FOONLY, INC.		23-DEC-79 15:01	
		CFDACN.DRW (4,41)	
DRAWN BY:	PAGE	OF	NUMBER /
APPROVED BY:	PROJECT:		REV.

CFTA-4
BUG FIXES: (shown in red)
CFTCMA
CFT FCT
CFT I1

FOONLY, INC.		16-MAY-80 02:15	
DRAWN BY:		CFTACN.DRW (5157,4622)	
APPROVED BY:		REV.	
PAGE	OF	NUMBER	
PROJECT:		<i>CFTA-4</i>	
		<i>MASTER COPY</i>

FOONLY INCORPORATED		20-DEC-79 05:50	
		PARITY.DRW(4,41)	
DRAWN BY:	PAGE 1 OF 1	NUMBER 2	REV.
APPROVED BY:	PROJECT:		0

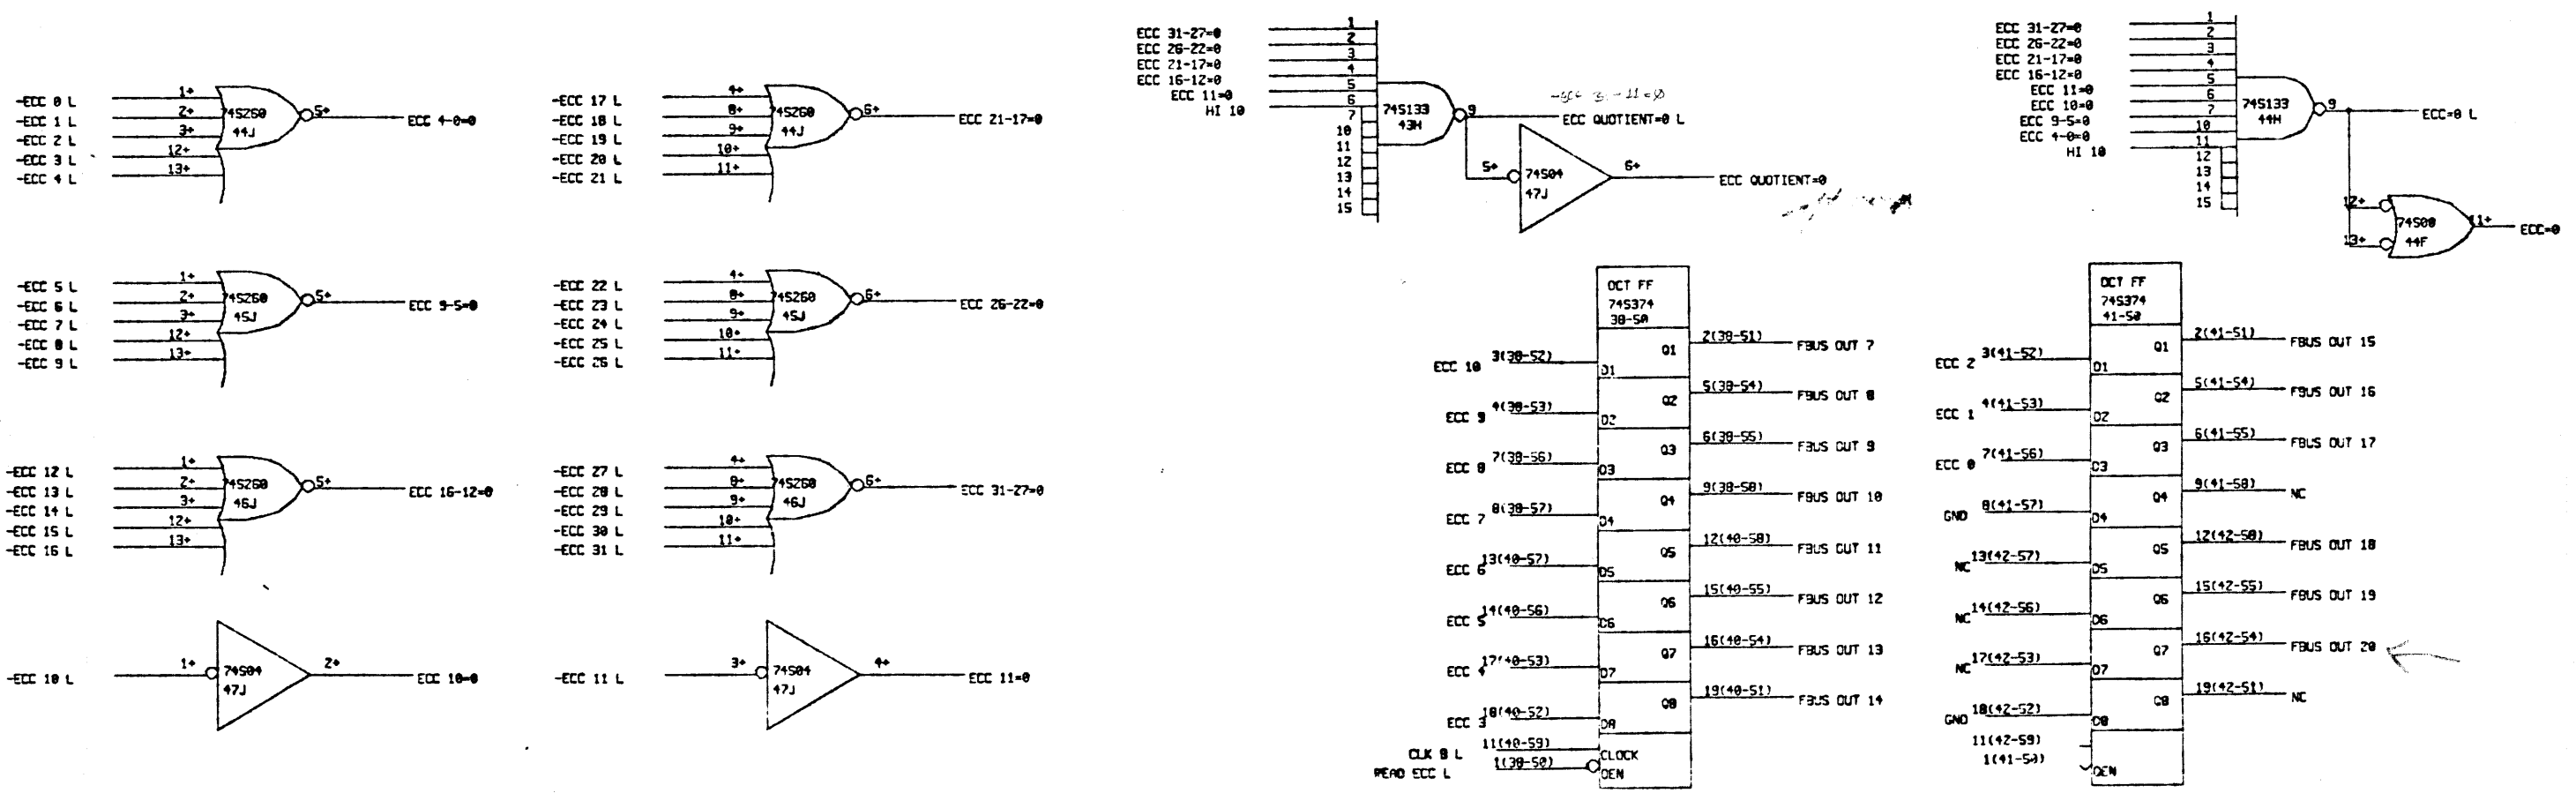
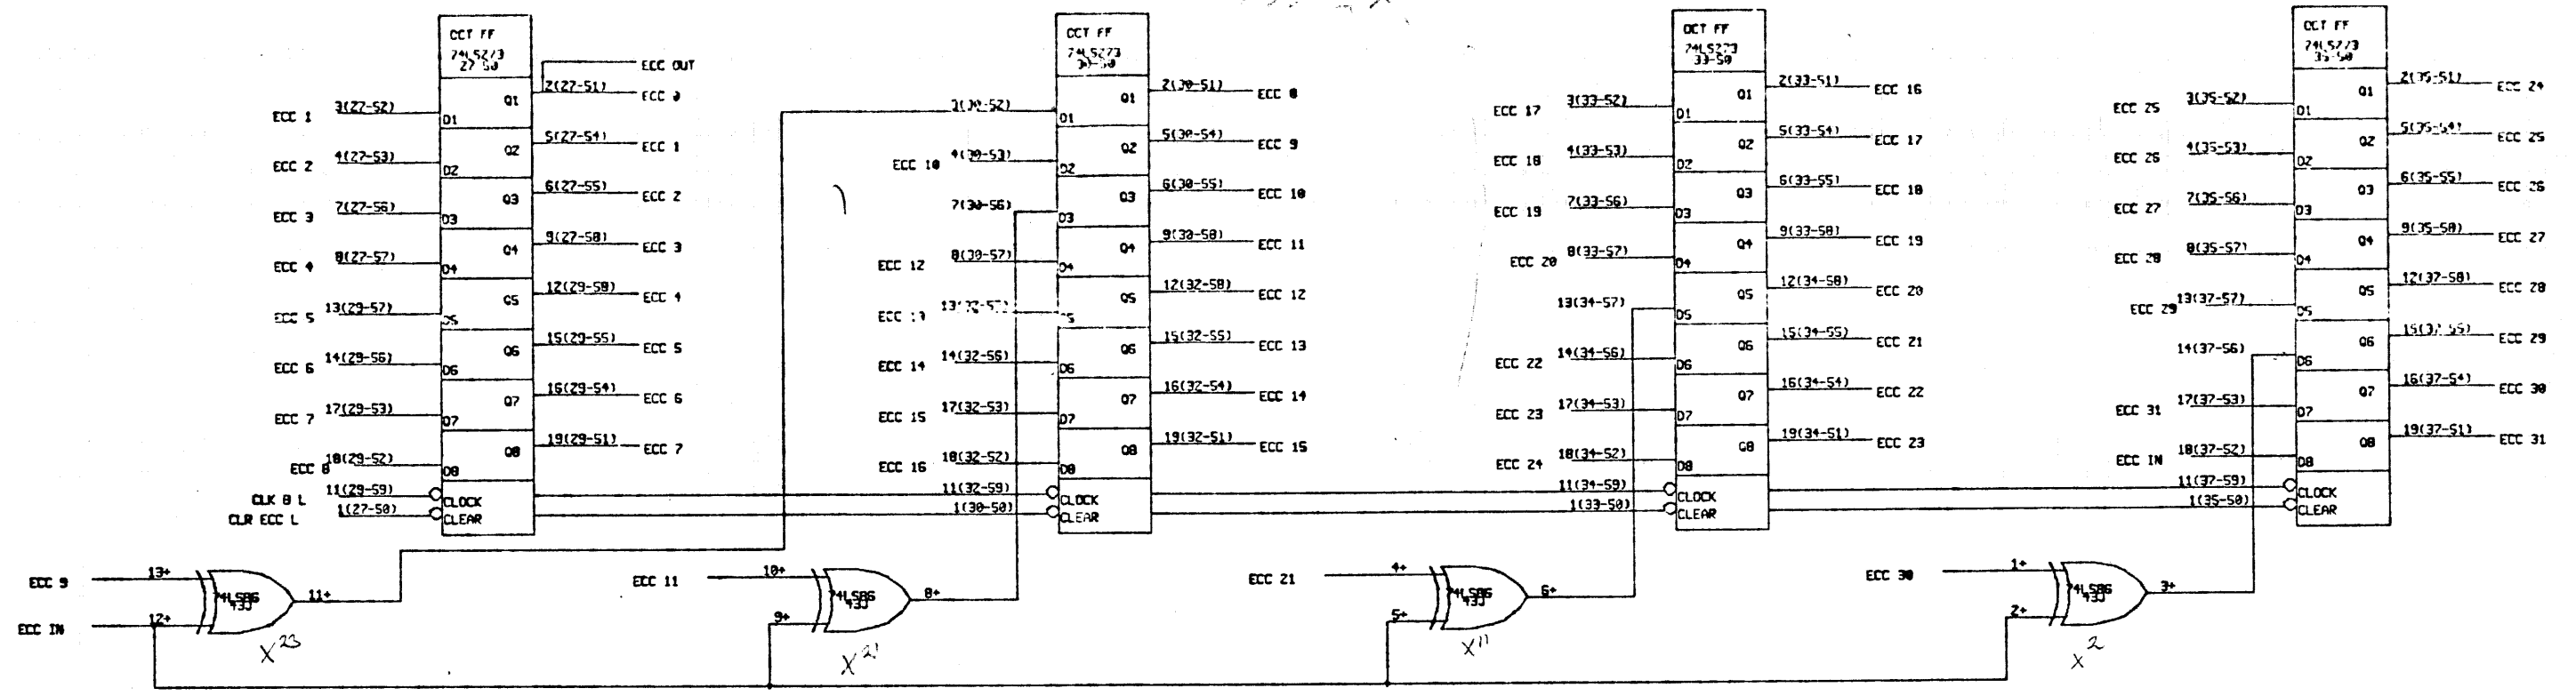
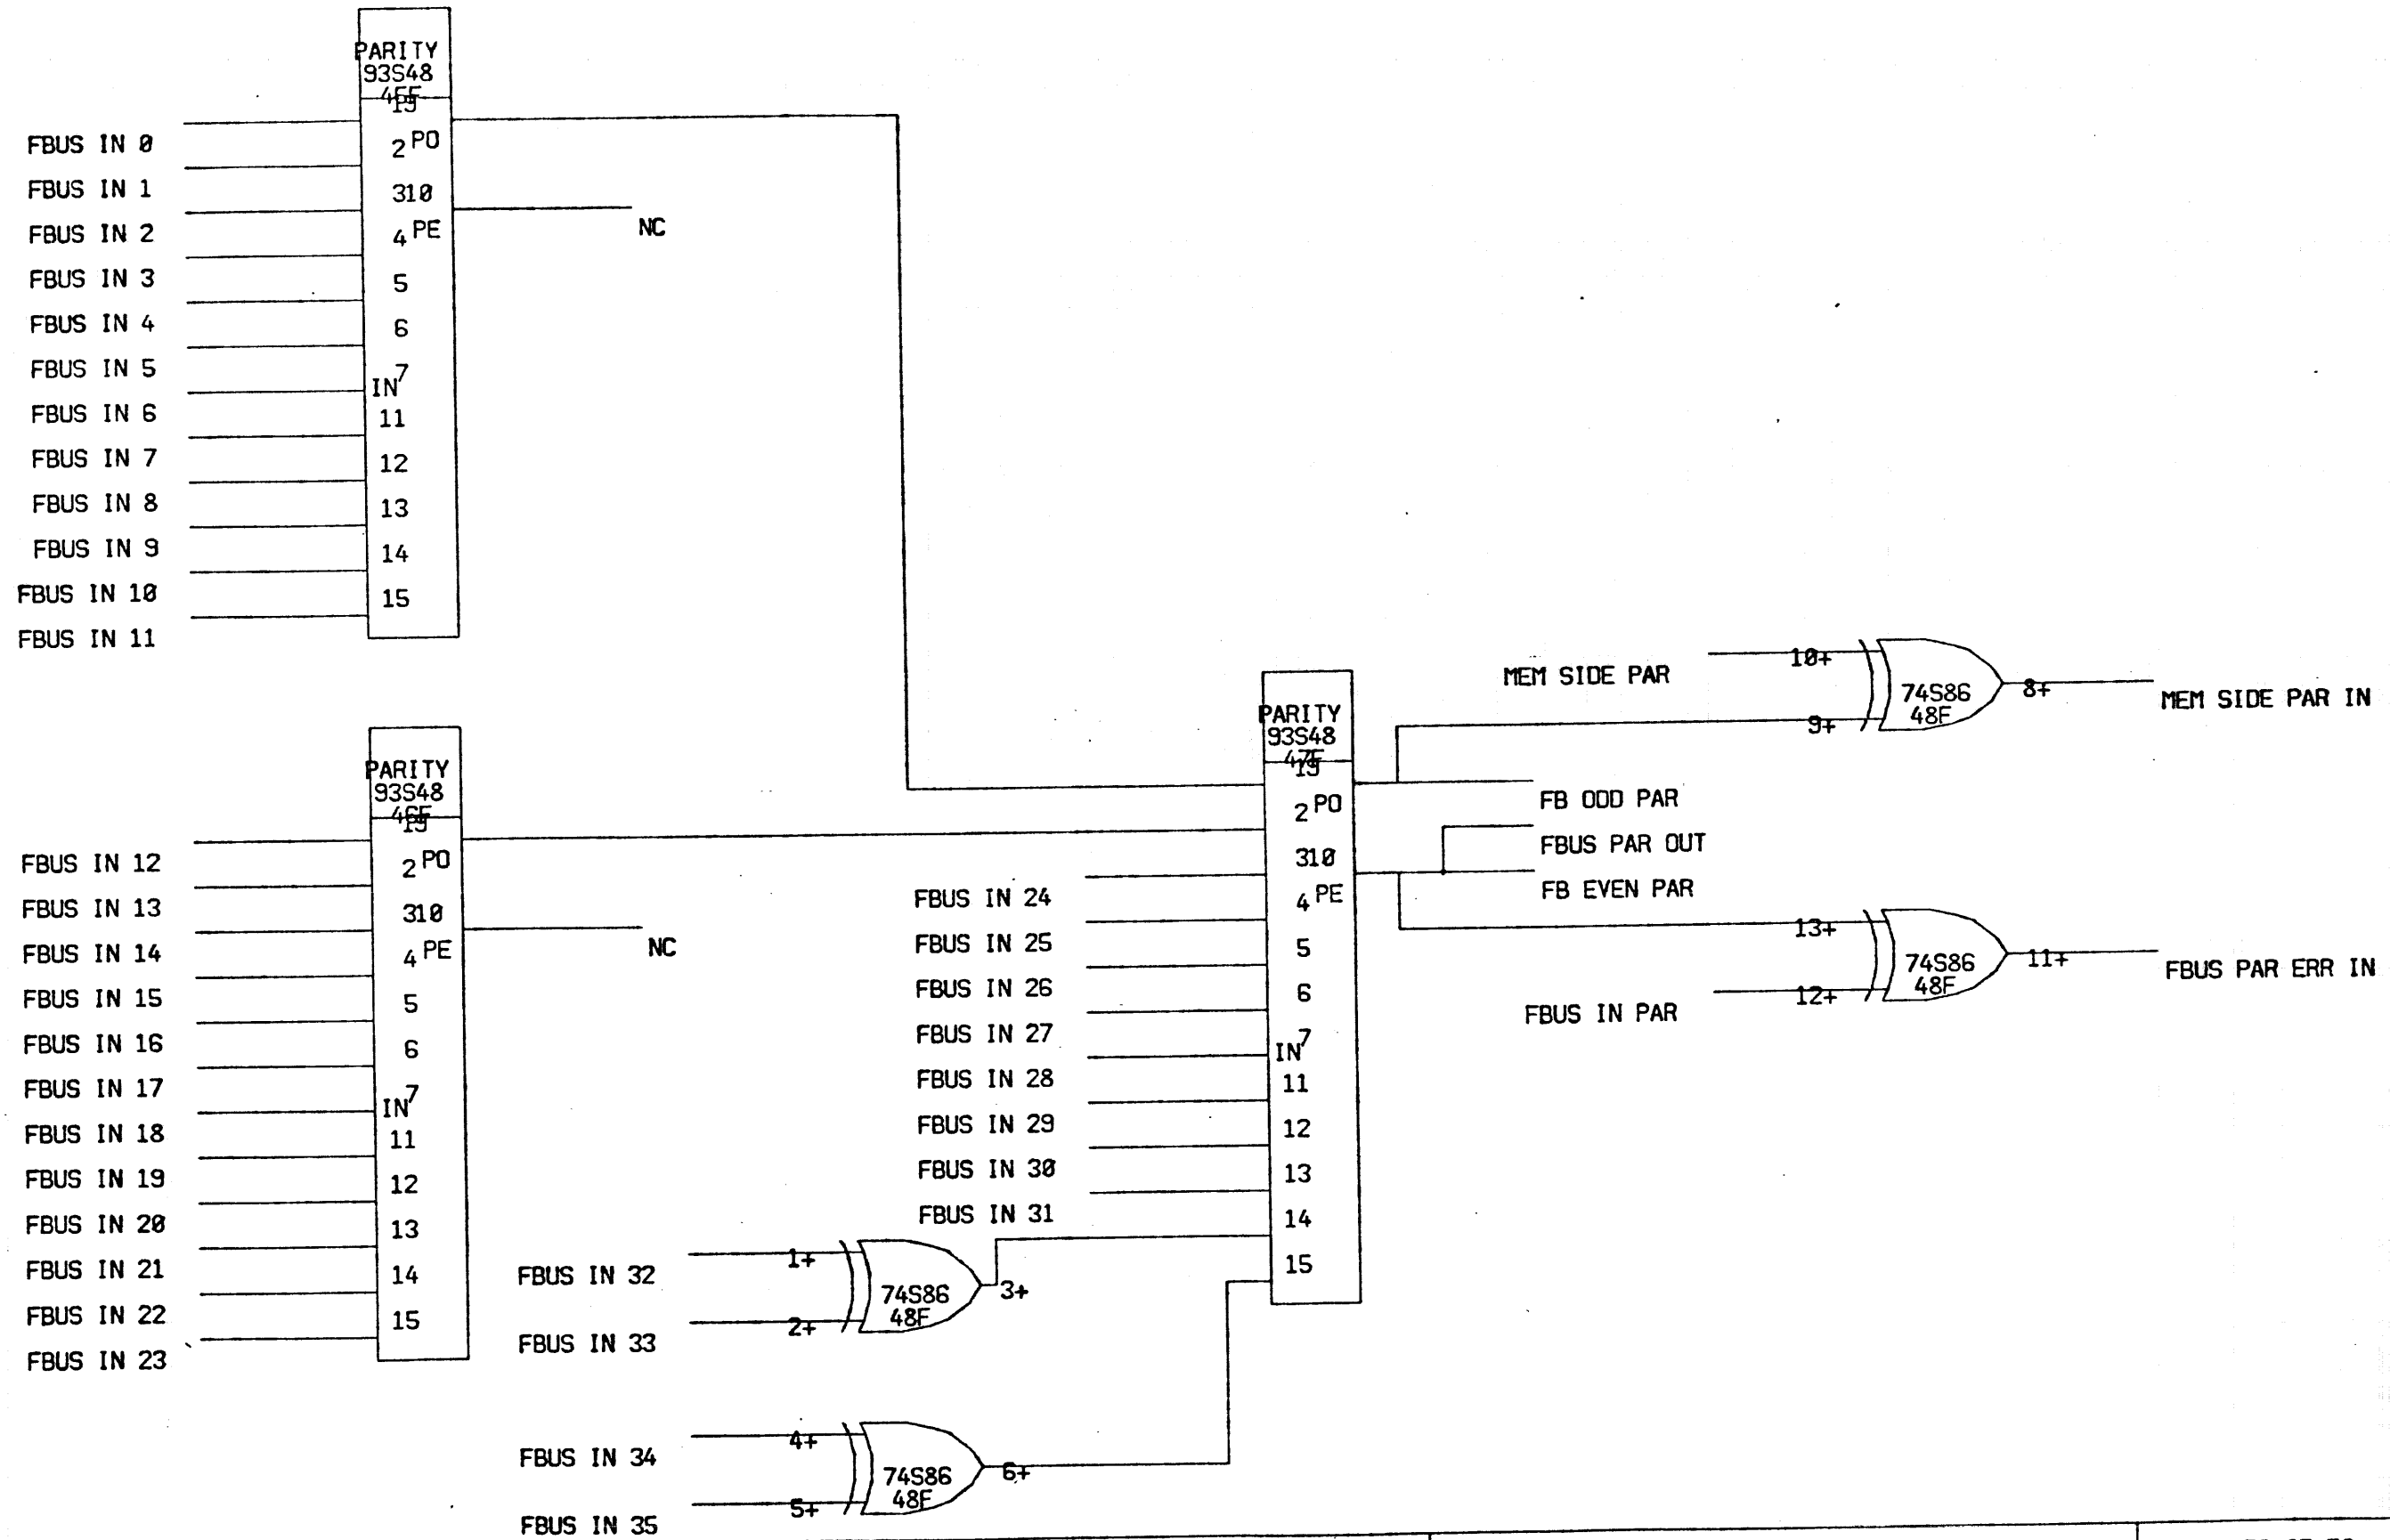
you should have done
 this
 check
 bus read second cycle
 and about address
 bus grant to read
 lower priority data
 tape is a higher priority
 line

FOONLY INCORPORATED		20-DEC-79 05:52	
		RBUF.DRW [4,41]	
DRAWN BY:	PAGE 1 OF 1	NUMBER 1	REV.
APPROVED BY:	PROJECT:		0

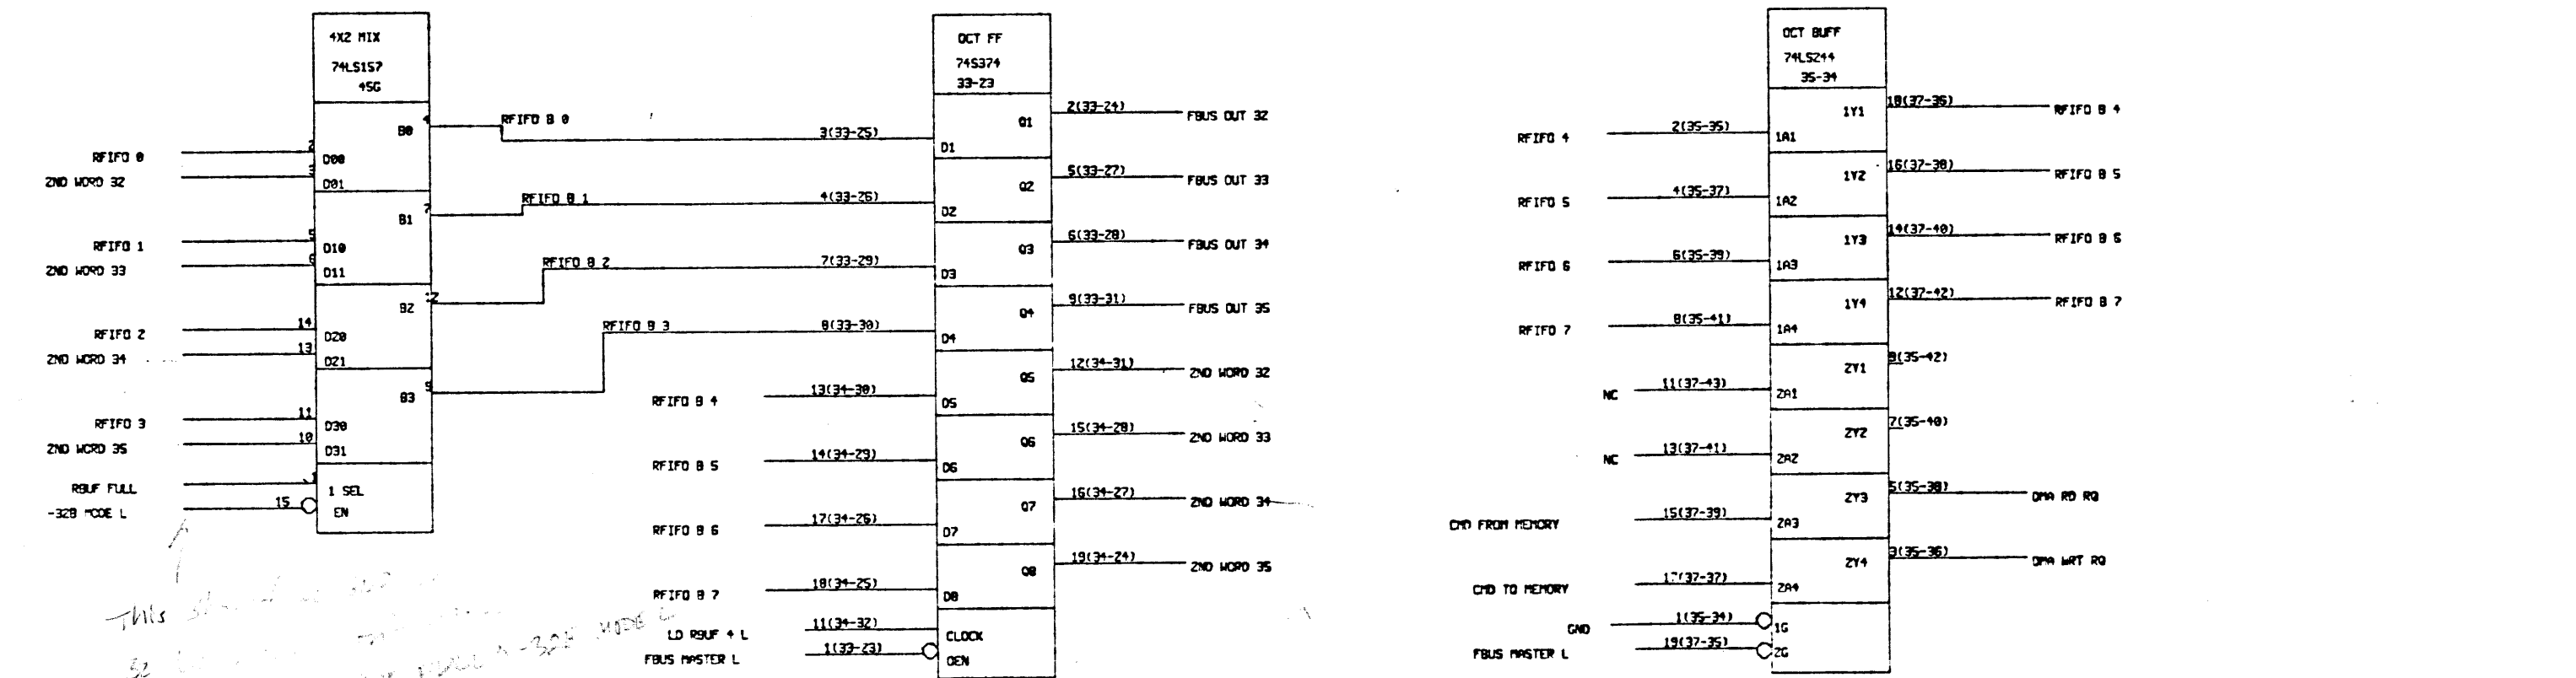
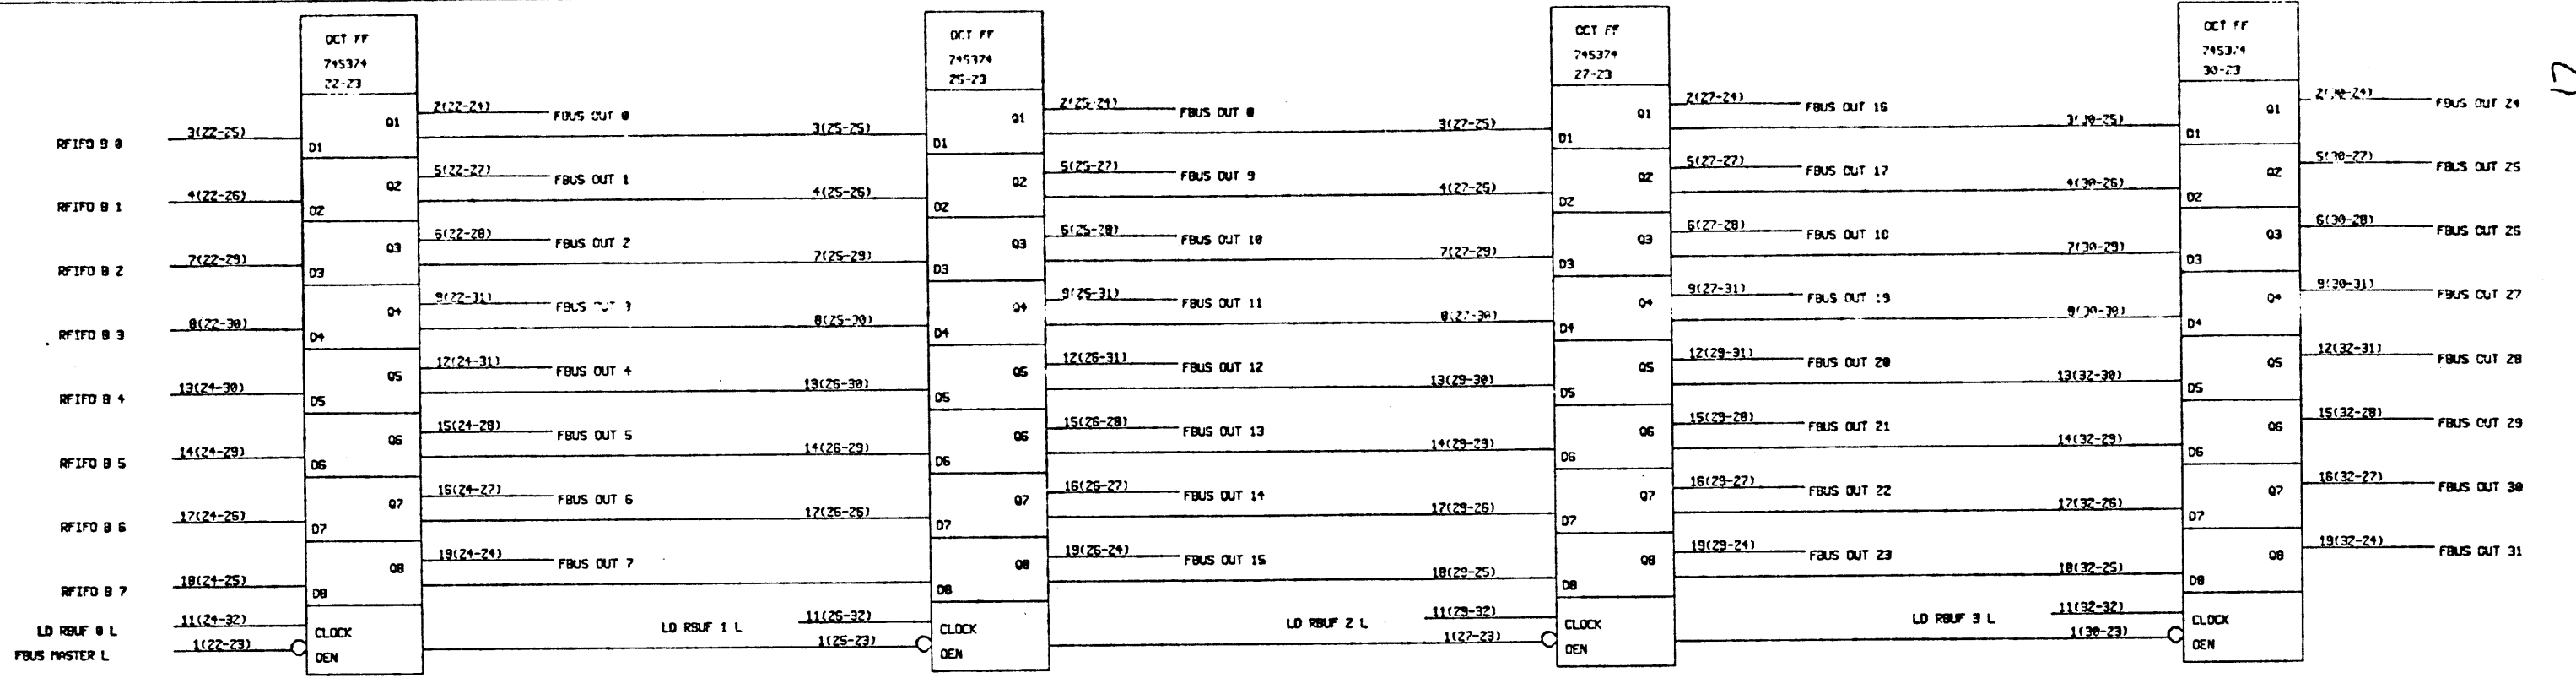
THIS should be 100%
 32 MODE L
 see also to RBUF FULL -32B MODE L
